CAROLINA NORTH PLANNING PROCESS SUMMARY OF KEY INTERESTS BY CATEGORY

This document seeks to provide a summary of the comments/questions that have been raised during the various Carolina North meetings and the Town's associated dialogue with the University. This summary begins with the Joint Town Council-UNC Board of Trustees Work Session on September 25, 2008, and continues forward to the present time (*Note: this document will be updated as additional meetings are summarized and key interests are organized by topic*). This document currently includes comments/questions from the following meetings:

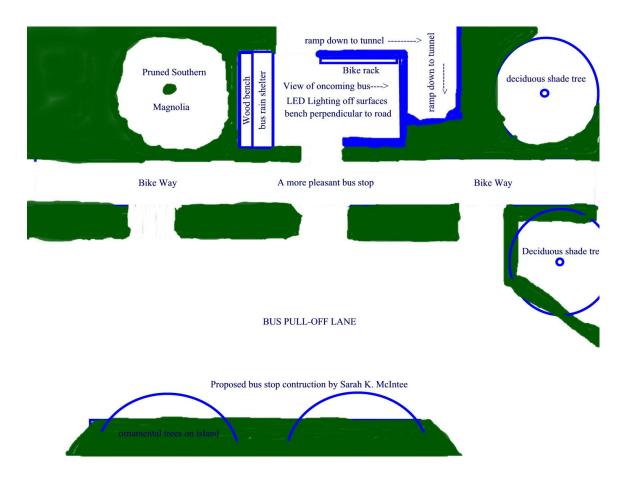
- There should be a pedestrian and bike tunnel under MLK at the main entrance. A pedestrian bridge, or anything that requires additional effort to get to, will not be used. It has to be right at the bus stops on MLK.

- In addition to having a pull off the road lane, which also can be used as a "kiss and go" lane, the bus stops should be *pleasant to be at*. They all should have *benches, lights, and rain shelter that face up street, perpendicular to the road, and NOT parallel with the road!* In front and also parallel with the street (an L-shape) should be waist high buffer, shrubs for in front of the shelter and fence along the street, allowing view of coming buses, but giving some protection from the splash and noise. Around the shelter back side and far side, there should be large leaf evergreen plants which add sound buffering. Street side in Chapel Hill is a very noisy place to be. If I take the bus to campus, I now take my ear plugs. The best sound barrier plant is the Southern Magnolia. See my sketch:
